**SUBJECT: Addendum No. 5**  
**Green Valley Road at Tennessee Creek Bridge Replacement Project**  
**(Contract No. PW 09-30407, CIP No. 77109)**

**GREEN VALLEY ROAD AT TENNESSEE CREEK**  
**BRIDGE REPLACEMENT PROJECT**  
**TRAFFIC HANDLING PLAN - STAGE 0**

SHEET TH-1  
 23 OF 61  
 W.O. No. 77109

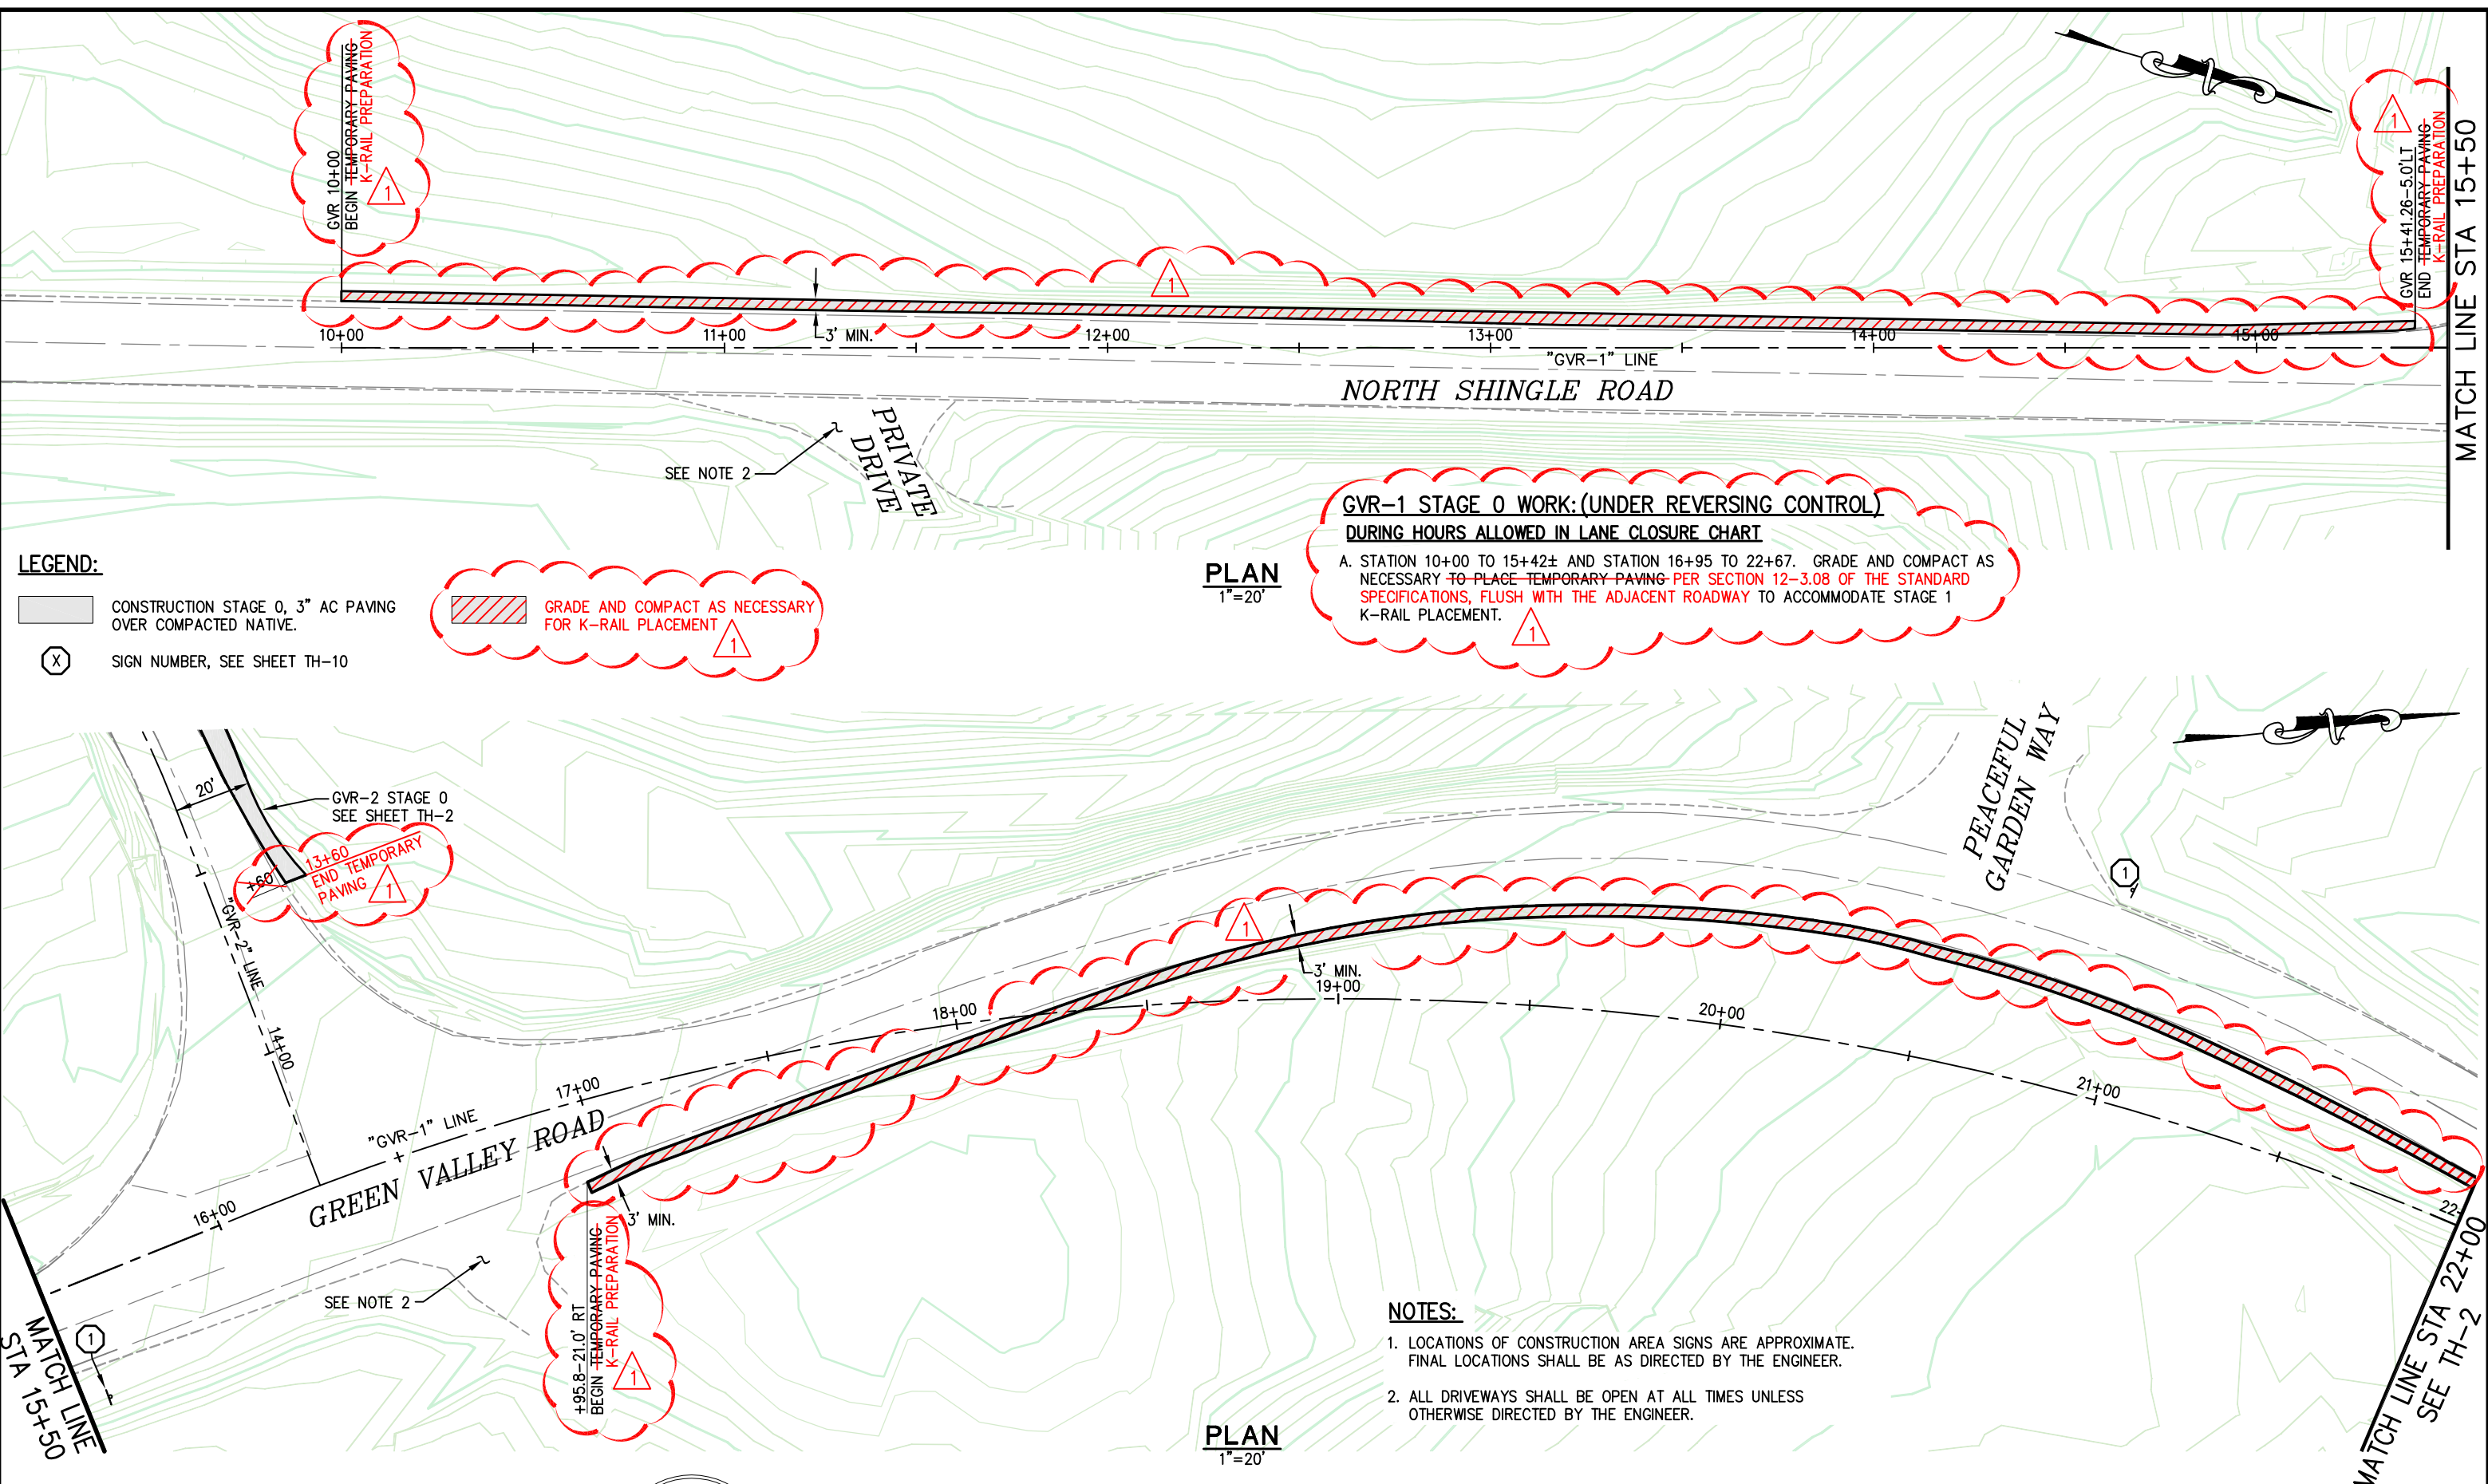
ITEM NO.	LOCATION, PAGE OR DRAWING NO.	DESCRIPTION OF CHANGE
5.01	Plan Sheets 23, 24, and 31	Plan sheets TH-1 (23 of 61), TH-2 (24 of 61), and TH-9 (31 of 61) have been revised to replace the temporary paving with graded and compacted native material. <b>Bidders are instructed to replace original plan sheets 23 of 61, 24 of 61, and 31 of 61 with the revised sheets 23 of 61, 24 of 61, and 31 of 61 attached to this Addendum No. 5.</b>

GRADE AND COMPACT AS NECESSARY FOR K-RAIL PLACEMENT

SHEET TH-7  
 29 OF 61  
 W.O. No. 77109

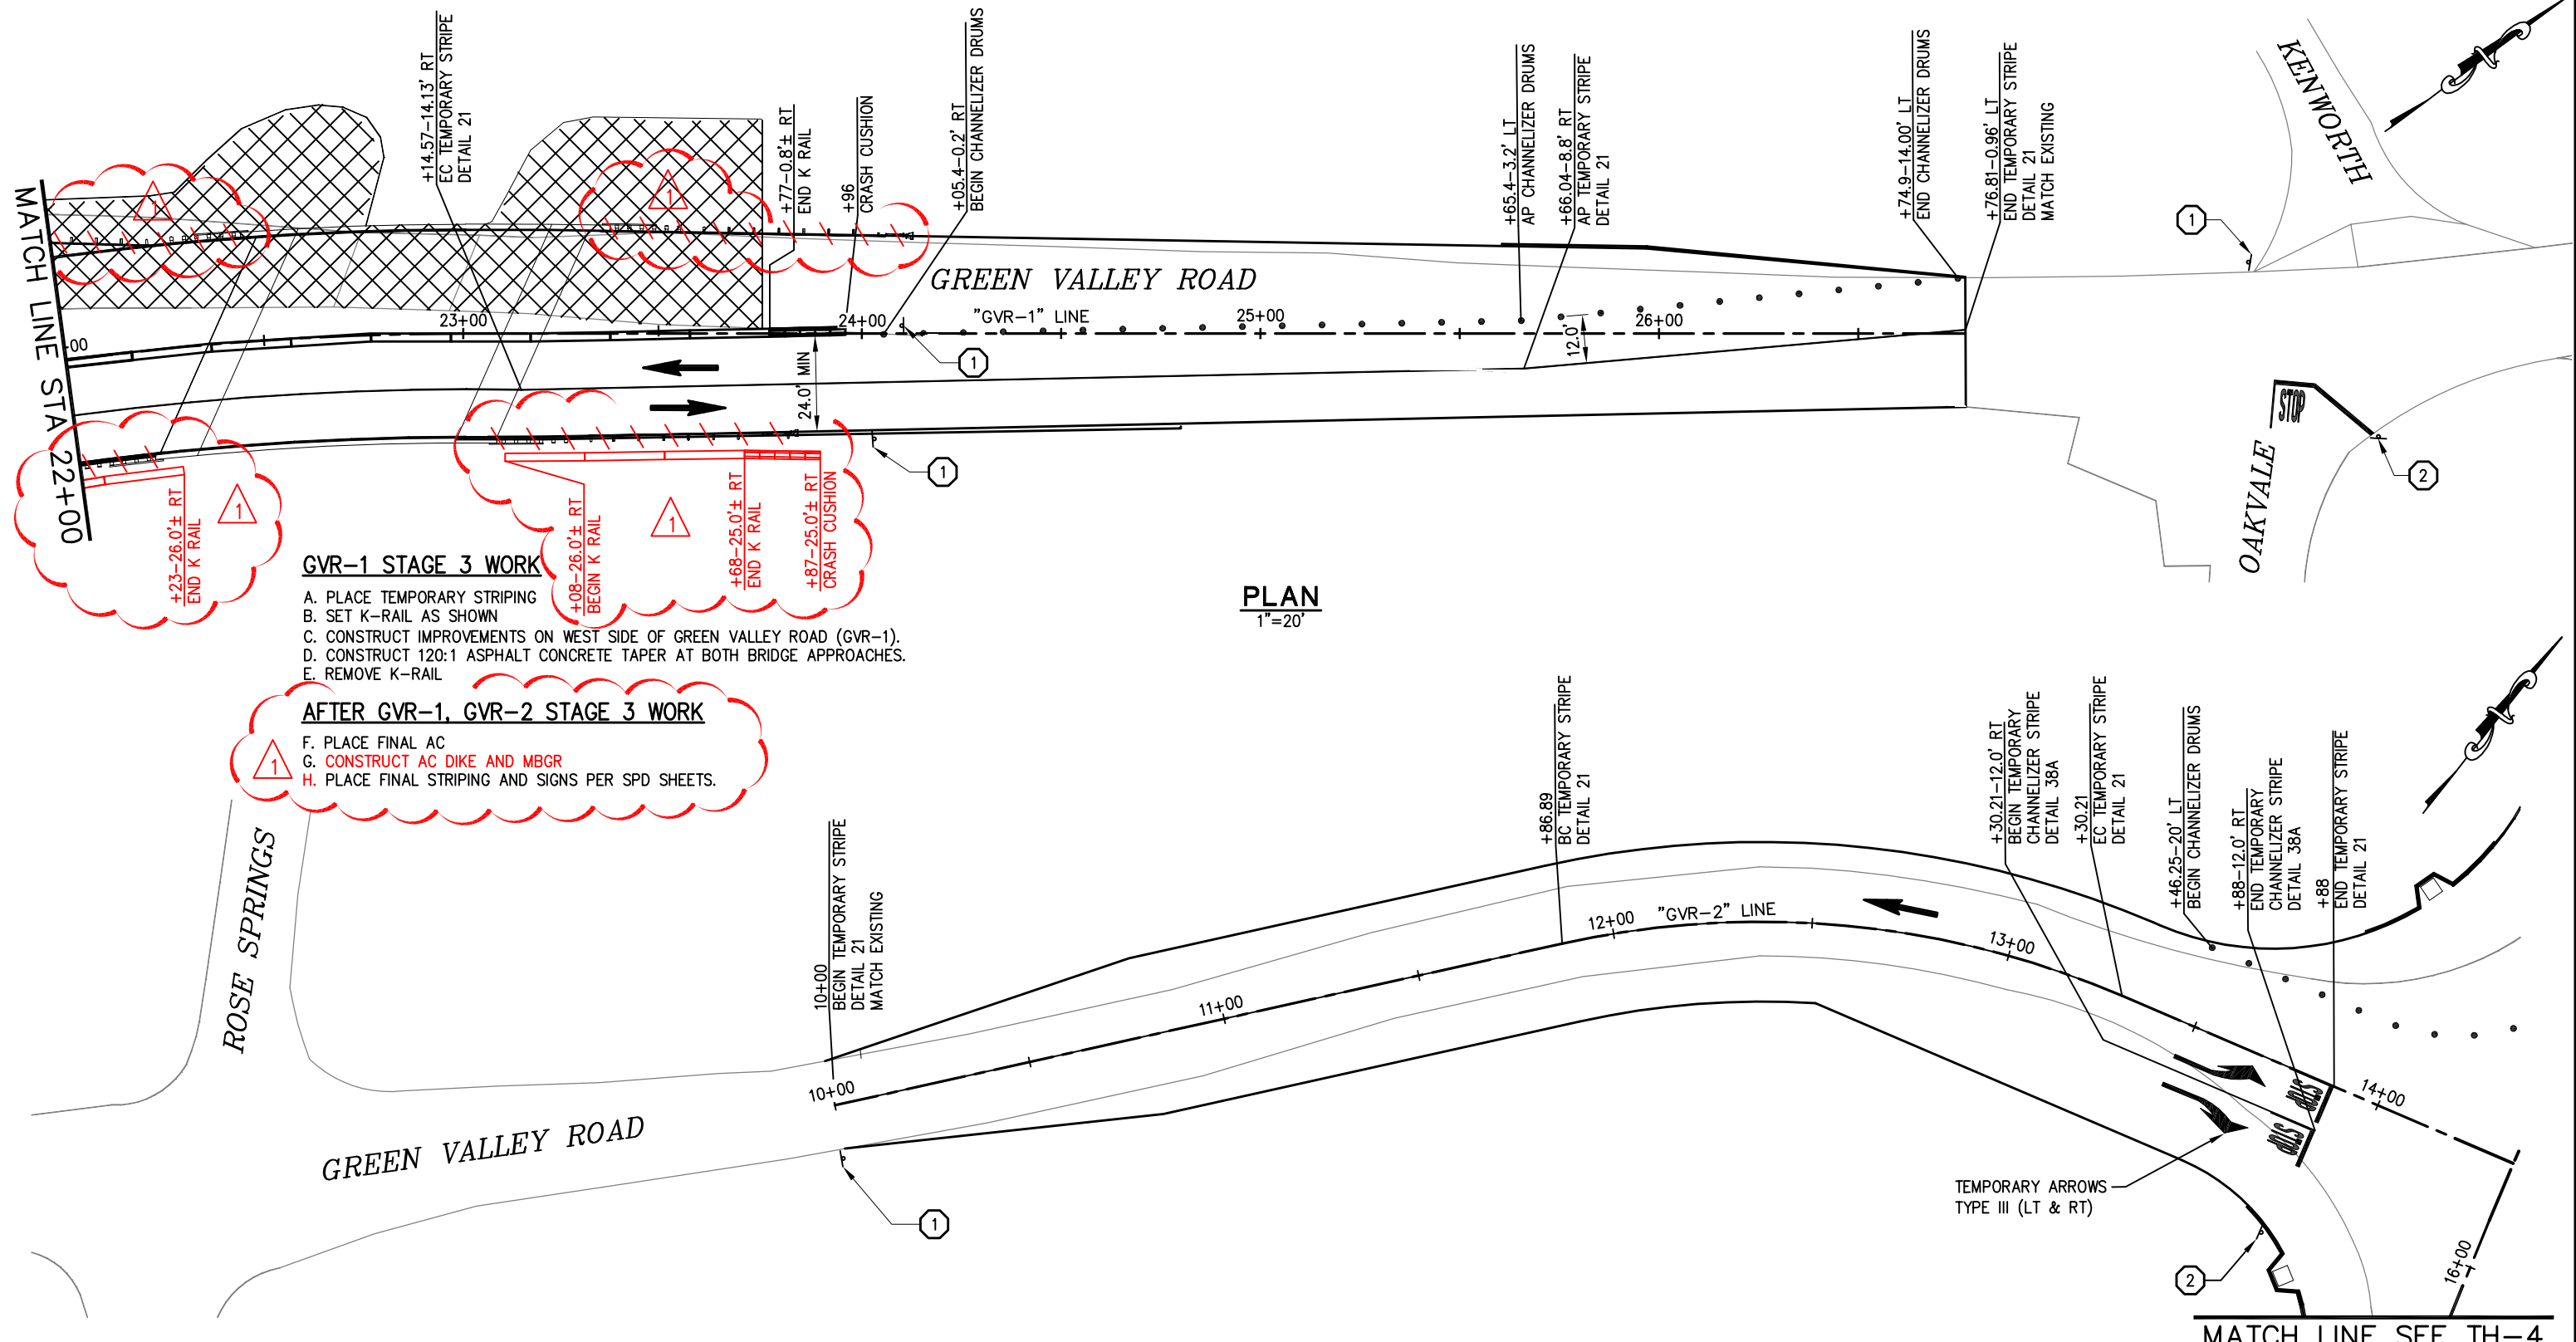
5.02	Plan Sheets 29, 30, and 31	Plan sheets TH-7 and TH-8 have been revised to show the use of Temporary Railing (Type K) with Temporary Crash Cushions in place of Metal Beam Guardrail until after the final lift of AC and AC Dike is placed. Plan sheet TH-9 has also been revised to reflect this change. <b>Bidders are instructed to replace original plan sheets 29 of 61 and 30 of 61 with the revised sheets 29 of 61 and 30 of 61 attached to this Addendum No. 5.</b>
